STATE BUILDING CODE COUNCIL

2018 Washington State Energy Code Development

Energy Code Proposal Short Form

Code Section #: C303

Structural glazing (Equation 3)

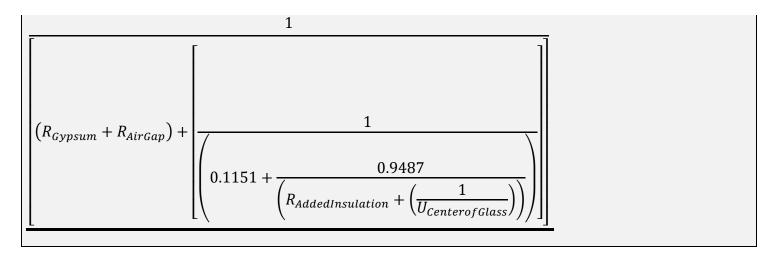
Proposed revisions to the current U-factor equations from C303.1.5 from the 2015 Seattle Energy Code (existing underlines in the text have been removed for clarity):

The current spandrel panel U-factor calculations in section C303.1.5 of the 2015 Seattle Energy Code appear to be incorrect as the U-factors in Table C303.1.5 cannot be replicated using the listed equations. The current equations appear to show $R_{AddedInsulation}$ and $U_{CenterofGlass}$ as elements in parallel; the proposed equations revise this to assume they are in series. The proposed U-factor calculations can replicate the U-factors in the table. JRS understands that these equations originally came from the California Energy Code (Title 24, Part 6), which also prints these equations incorrectly.

Additionally, Equation 1 uses U_{qypsum} rather than $U_{Overall}$.

$$U_{Overall} = \boxed{ \left(R_{Gypsum} + R_{AirGap} \right) + \boxed{ \frac{1}{\left(0.1151 + 0.9487 \left(\frac{1}{R_{AddedInsulation}} \right) + U_{CenterofGlass} \right) \right) } }$$
